Serial No. 17-325  
Docket Nos.: 50-338/339  
50-280/281  
52-017  
72-2/16/55/56  
Page 1 of 4

**PROPOSED CONSOLIDATED  
EMERGENCY OPERATIONS FACILITY**

## **Attachment 1**

### **Discussion of Proposed Change**

Figure 2.4-1: Layout of Proposed CERC

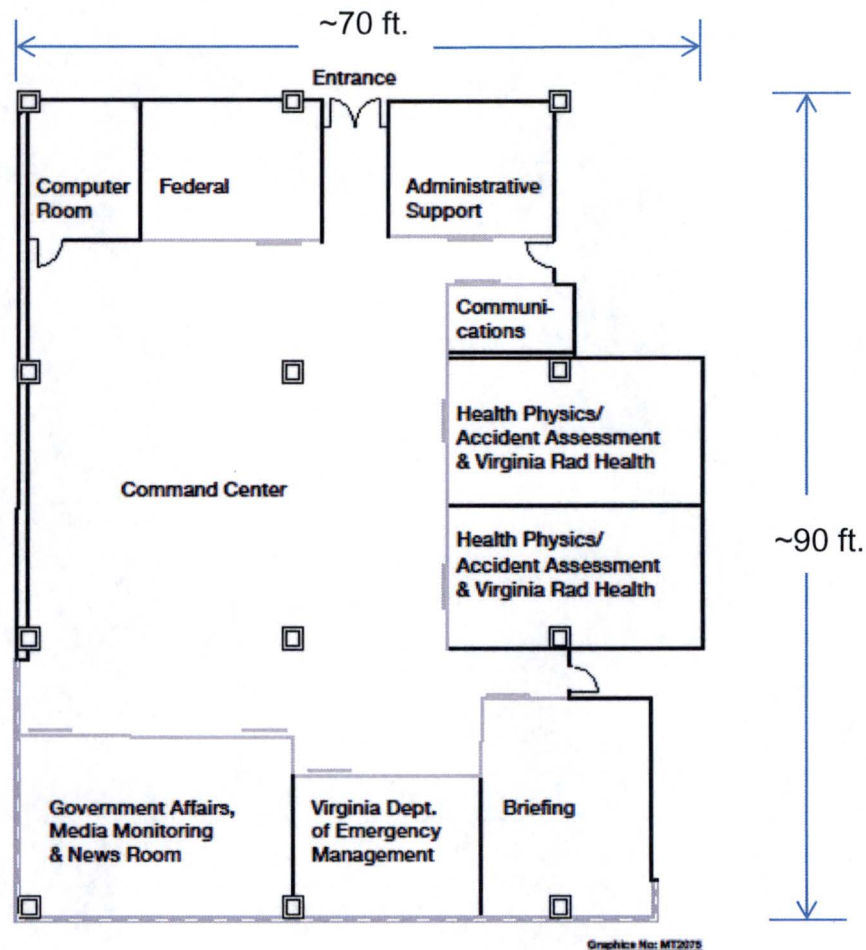
Figure 2.4-1: depicts the layout of the proposed CERC:

RADIATION PROTECTION ORGANIZATION  
FIGURE 5.5.c

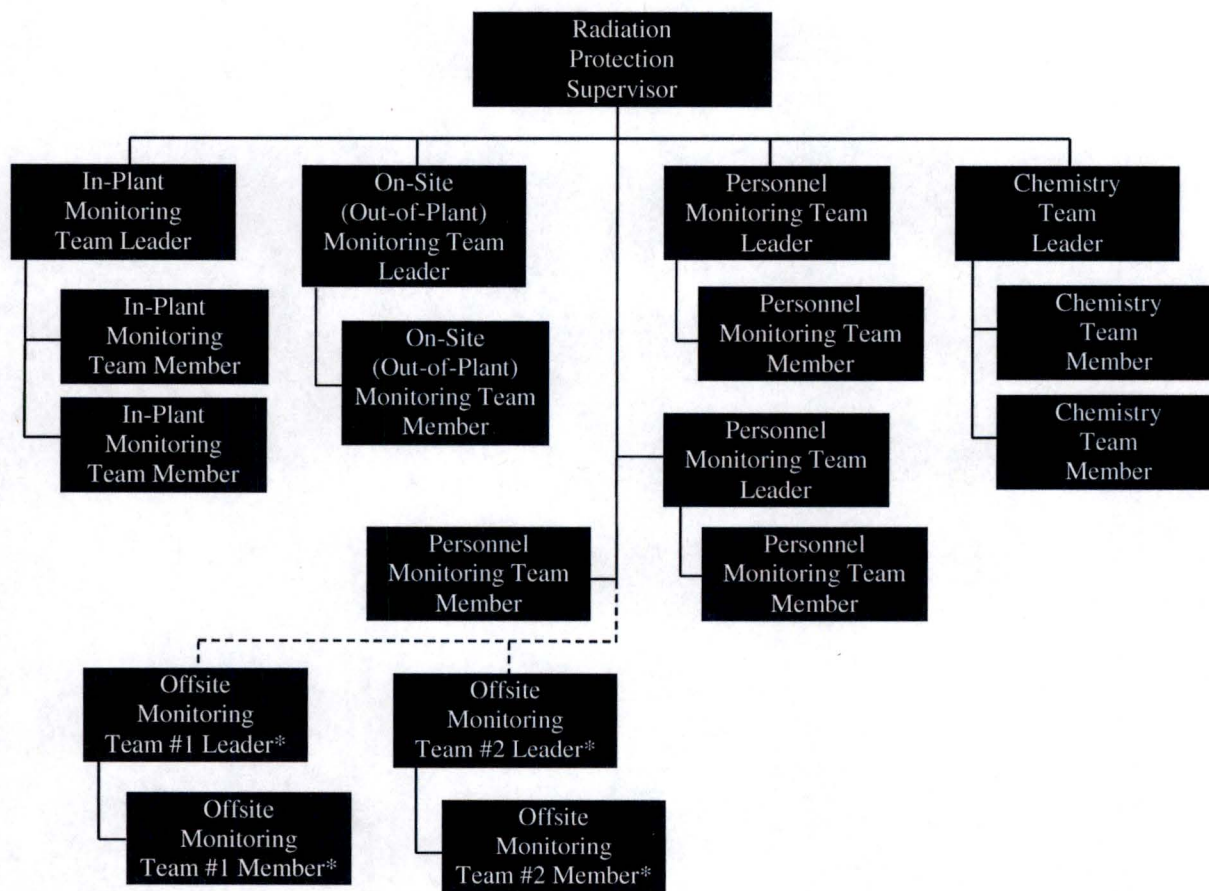
\* Offsite Monitoring Teams are controlled by CERC Accident Assessment Team after being staged.

FIGURE 5.5.d

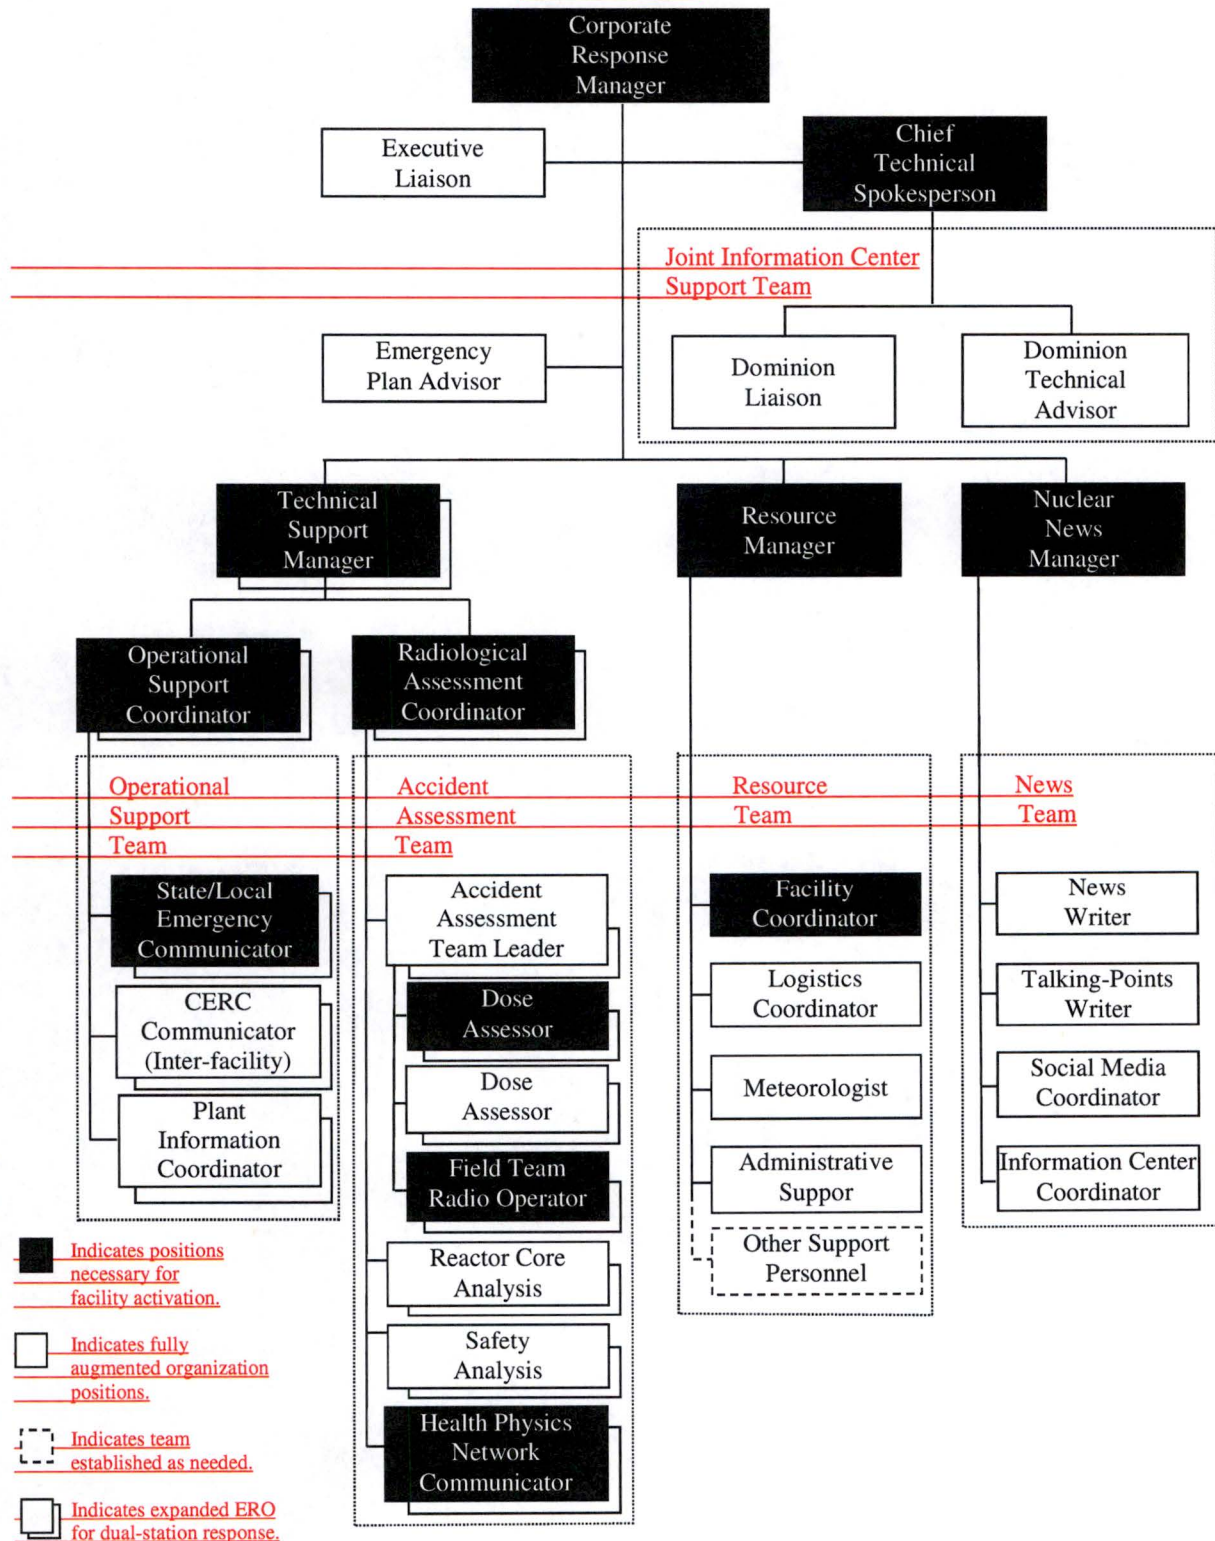
<p>Meteorology  Safety Analysis  Operations Support  (CEOF Dose Assessment)</p>	
Figure (Page 5–5)	<p>CORPORATE EMERGENCY RESPONSE CENTER  Minimum Organization For Activation</p>	<p>Added NAEP &amp; SEP Figures 5.5d. (Also added Figures 5.5a-c for TSC, OSC and on-site HP.)</p>
Figure (Page 5–6)	<p>CORPORATE EMERGENCY RESPONSE CENTER  Fully Staffed Organization</p>	<p>Added NAEP &amp; SEP Figures 5.5d.</p>

5.4.7	Federal Radiological Monitoring and Assessment Center (FRMAC) Operations Plan	5.17
Table 5.1	Minimum Shift Manning Requirements	5.18
Table 5.2	Emergency and Recovery Corporate Response Required for Nuclear Station Emergencies (Alert Status And Above)	5.21
Table 5.3	Cities and Counties Within the North Anna 50 Mile Emergency Planning Zone	5.22
Figure 5.1	Station Emergency Organization Prior to Augmentation	5.23
Figure 5.2	Station Emergency Organization Following Augmentation	5.24
Figure 5.3	Station to Support Group Interface Prior to Augmentation of the Onsite Emergency Organization	5.25
Figure 5.4	Station to Support Group Interface After <u>LEOF-CERC</u> Activation	5.26
<u>Figure 5.5.a</u>	<u>Technical Support Center Organization</u>	
<u>Figure 5.5.b</u>	<u>Operational Support Center Organization</u>	
<u>Figure 5.5.c</u>	<u>Radiation Protection Organization</u>	
<u>Figure 5.5.d</u>	<u>Corporate Emergency Response Center Organization</u>

FIGURE 9.1

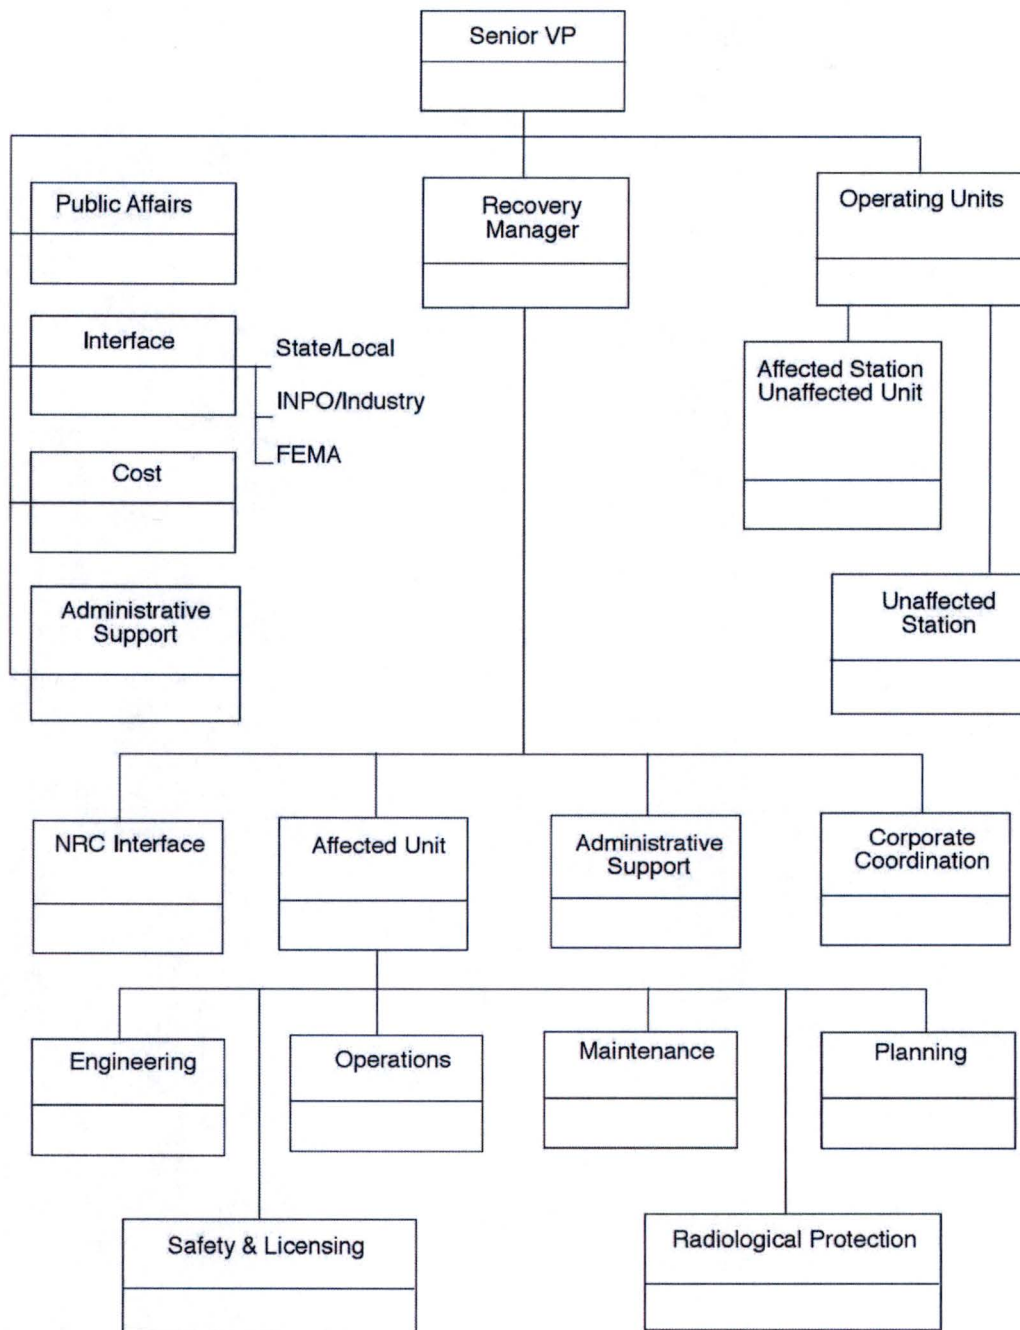
7.2	<p><b>Recovery Organization</b></p> <p>Figure 7.1, Example Recovery Organization, is representative of a typical organization that may be designated by the Recovery Manager. Responsibilities of the recovery organization include defining recovery objectives, developing a plan to accomplish these objectives, establishing controls and anticipating potential complications, monitoring the recovery effort and adjusting the plan accordingly, and evaluating accomplishments against the designated objectives.</p> <p>Under the direction of the Recovery Manager, the recovery organization addresses planning and coordination of the recovery effort (in cooperation with governmental officials, when required). Federal and state agencies may augment the recovery organization and participate in establishing recovery objectives.</p>	Added CERP-specific content to NAEP & SEP Sections 9.0 and 9.1.
Figure (Page 7–3)	<p><b>FIGURE 7.1</b></p> <p><b>EXAMPLE RECOVERY ORGANIZATION</b></p>	Relocated figure to NAEP & SEP Sections 9 as Figure 9.1.

The recovery process will be managed by a special, designated organization composed of Dominion personnel. The recovery organization is described in ~~the Corporate Emergency Response Plan~~ Figure 9.1. The basic organization may be modified, as required, to address the needs of the given situation. The ~~Recovery-Technical Support~~ Manager assumes control and direction of the recovery operation with the authority and responsibilities for implementing and administering the recovery plan and organizations set forth in the Corporate Emergency Response Plan. Responsibilities of the recovery organization include defining recovery objectives, developing a plan to accomplish these objectives, establishing controls and anticipating potential complications, monitoring the recovery effort and adjusting the plan accordingly, and evaluating accomplishments against the designated objectives.
